SERVICE BULLETIN
SUMMARY

TITLE: AIR CONDITIONING - DISTRIBUTION - INSPECTION OF DRAIN PIPES**MODIFICATIONS**

SERVICE BULLETIN No.: A320-21-1174

REVISION No.: 00 - Jan 28/08

Figure A-FAAAA - Sheet 01
AREA TO BE INSPECTED.

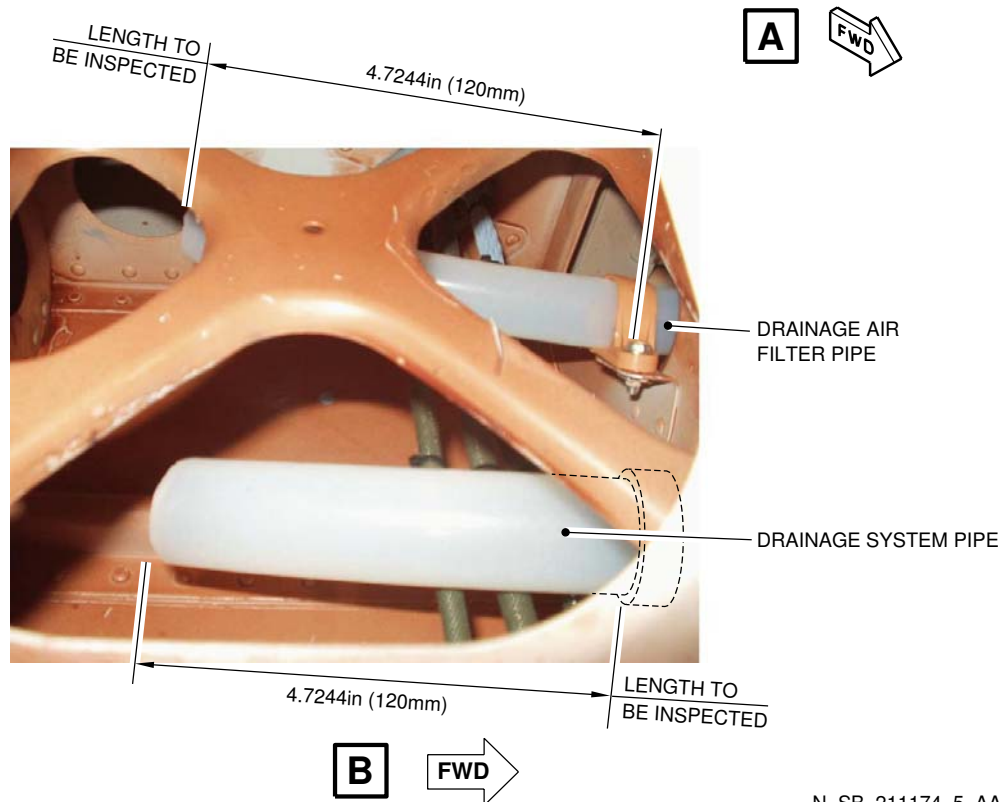
- (a) For the inspection area, Refer to [Fig. A-FAAAA](#)
- (b) Do a detailed visual inspection, Refer to [Fig. A-FABAA](#)
- (c) For the inspection report, Refer to [Fig. A-FADAA](#)

Figure A-FACAA - Sheet 01
REPAIR

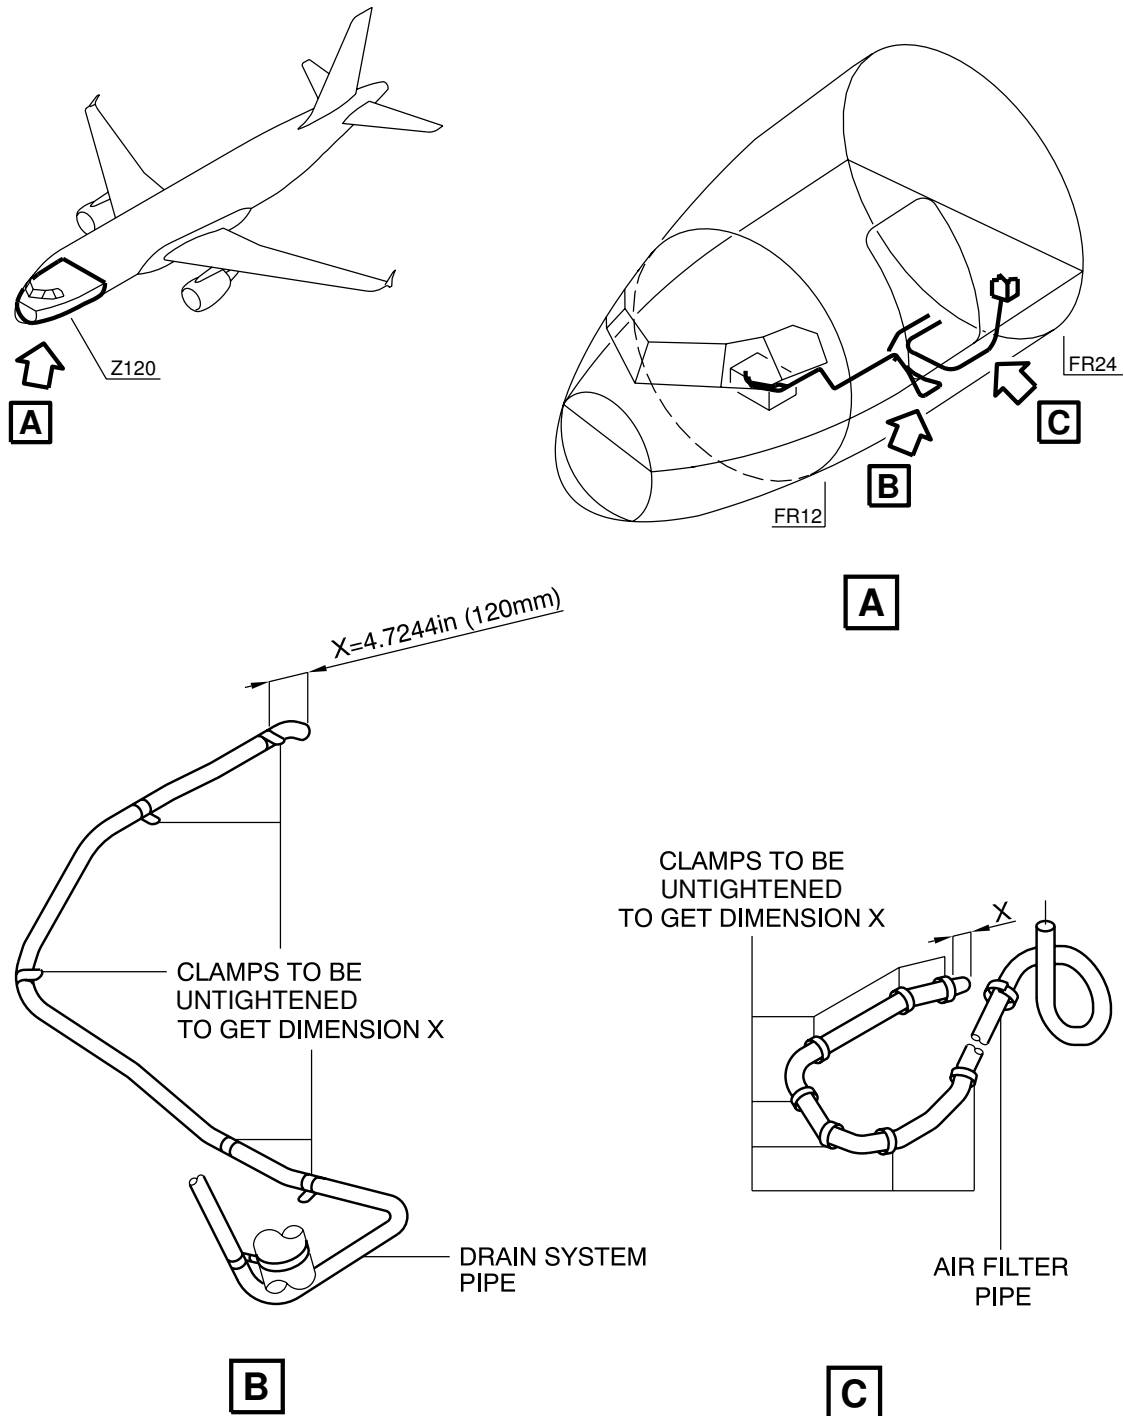
- (a) Loosen the 5 or/and 7 clamps shown on details B and C Refer to [Fig. A-FACAA](#)
- (b) Pull on the drain pipe(s) to get the suitable length of 4.7244 in. (120 mm)
- (c) Tighten the 5 or/and 7 clamps.
